ADDENDUM NO. 2
to
CONTRACT DOCUMENTS

for
ADDITIONS AND RENOVATIONS TO LITTLEBROOK ELEMENTARY SCHOOL
located at 39 Magnolia Lane, Princeton, NJ 08540

FVHD PROJECT NO. 5516D

Issued: March 24, 2026

Drawing Number
A001

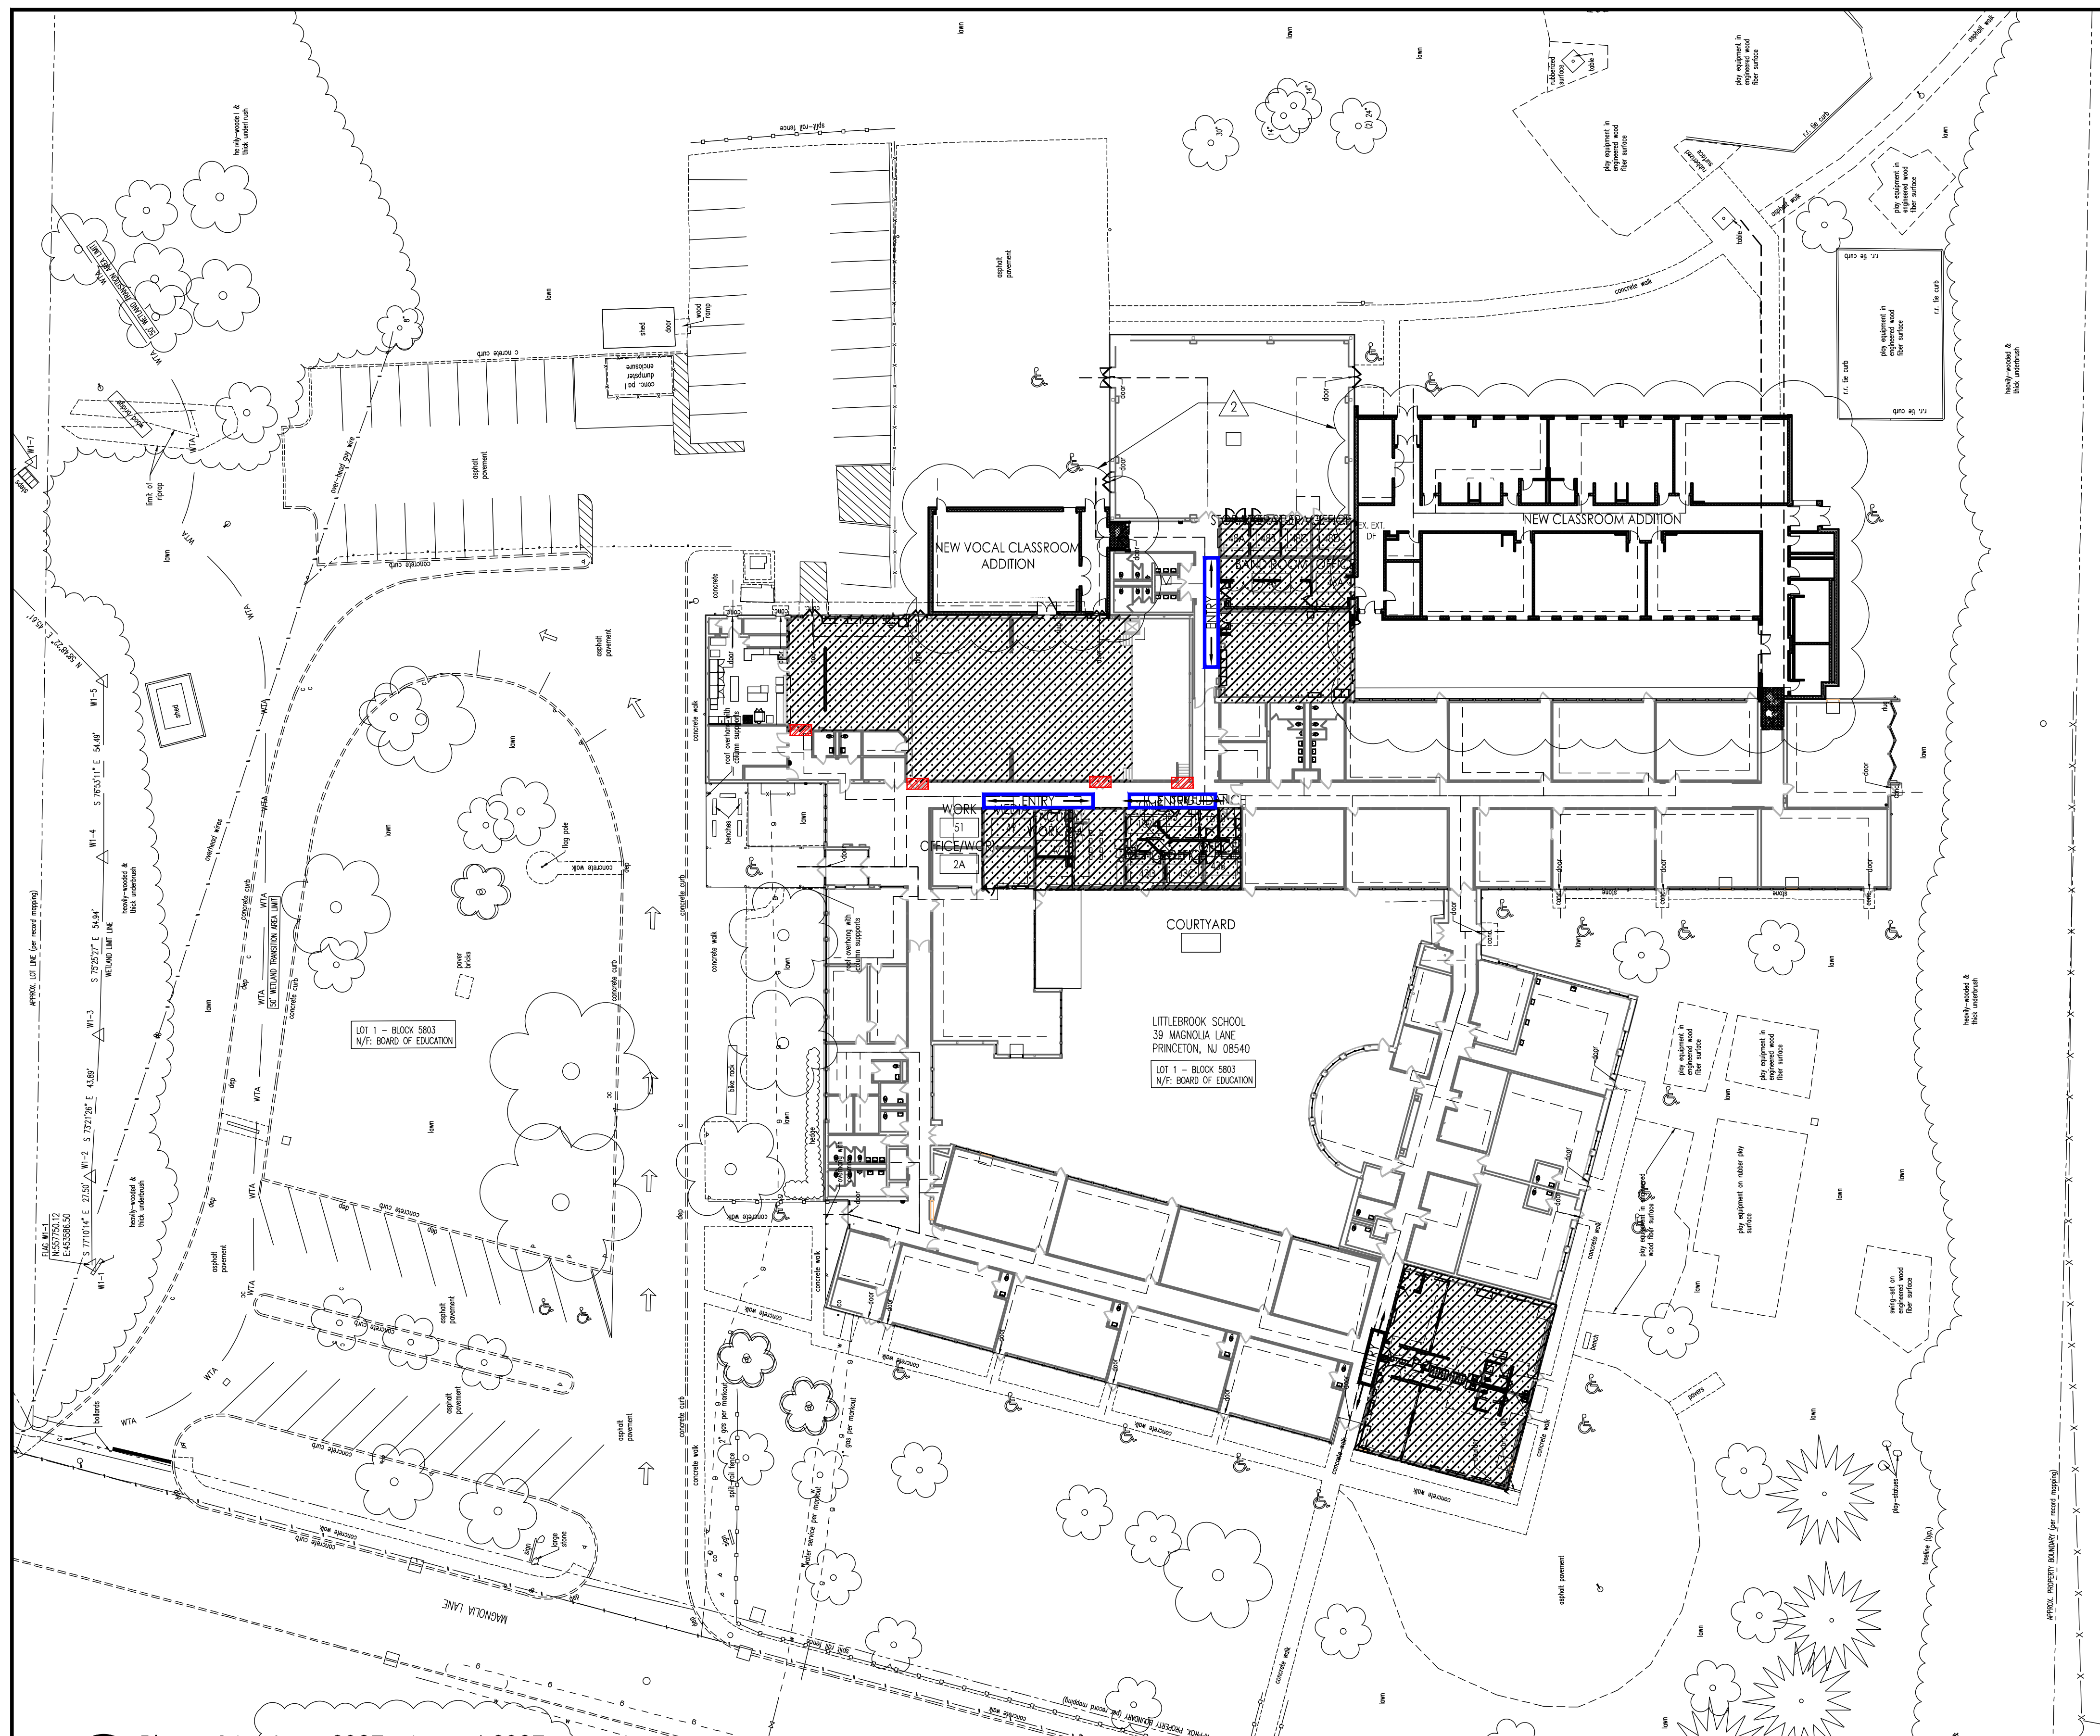
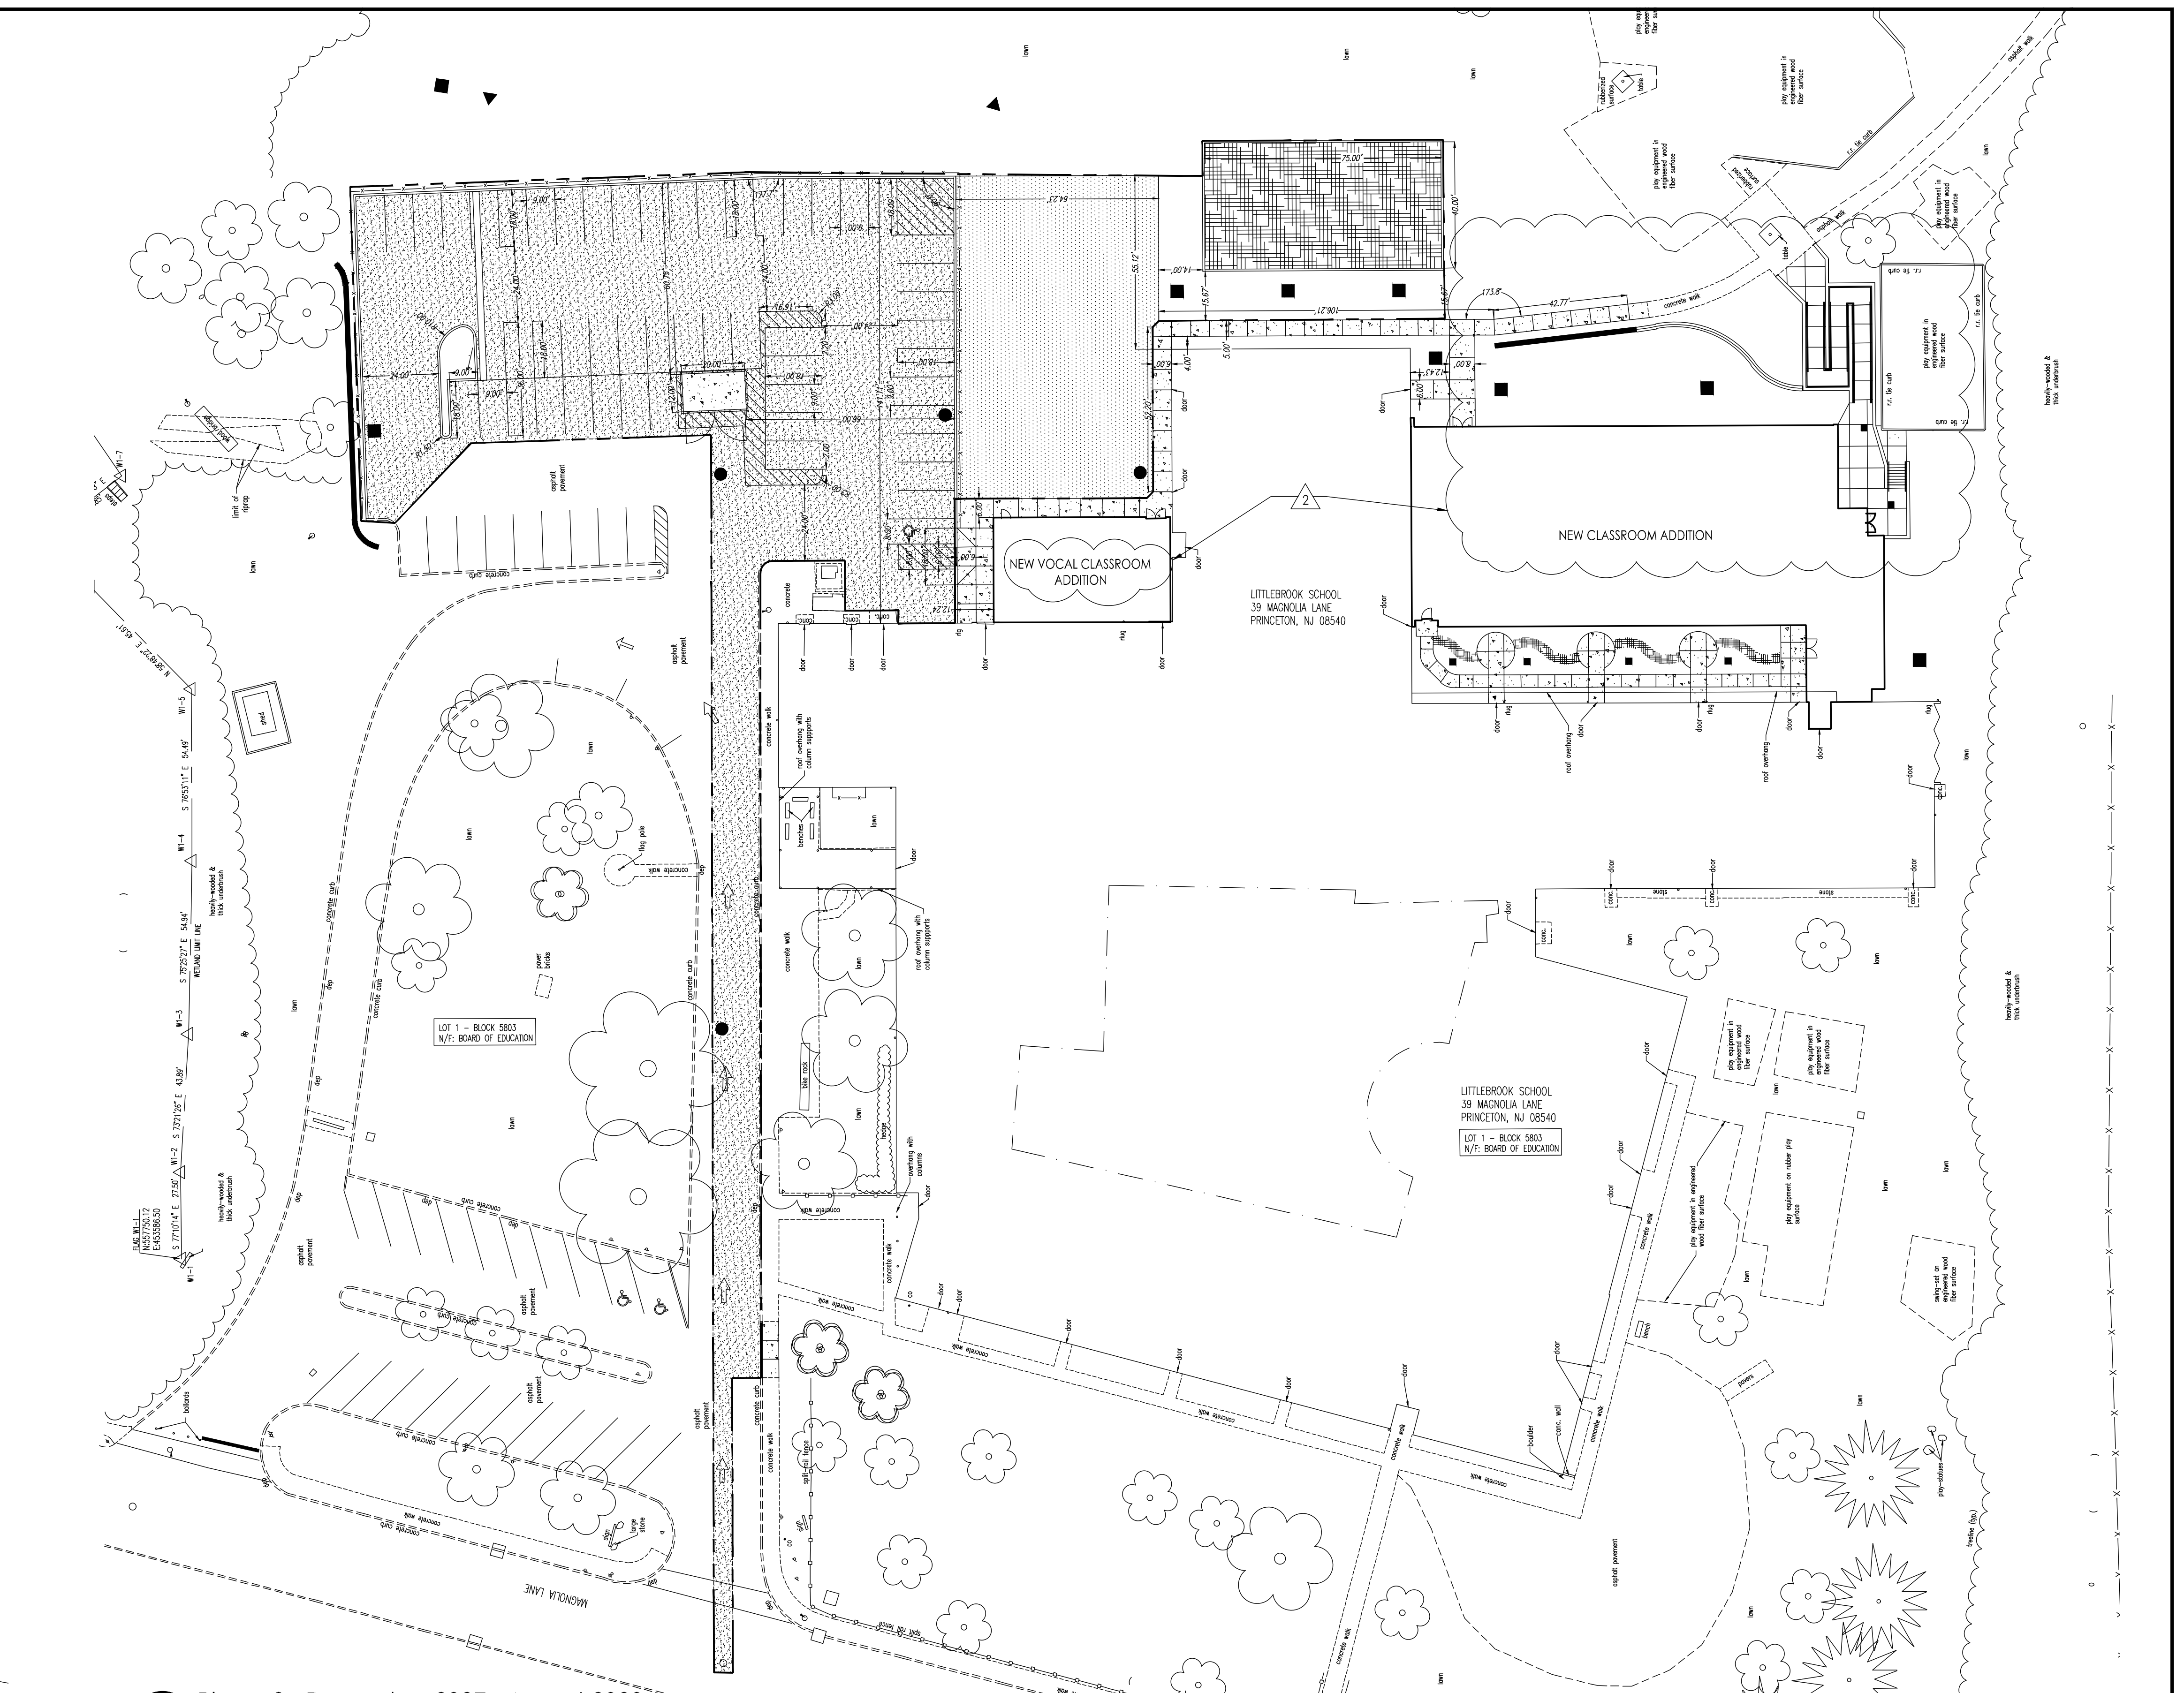
21. Question: Please provide layout and locations for temporary Partition if any requirement.

Response: Refer to Specification Section 01505, para 1.1, C.16. Refer to locations on revised drawing A001.
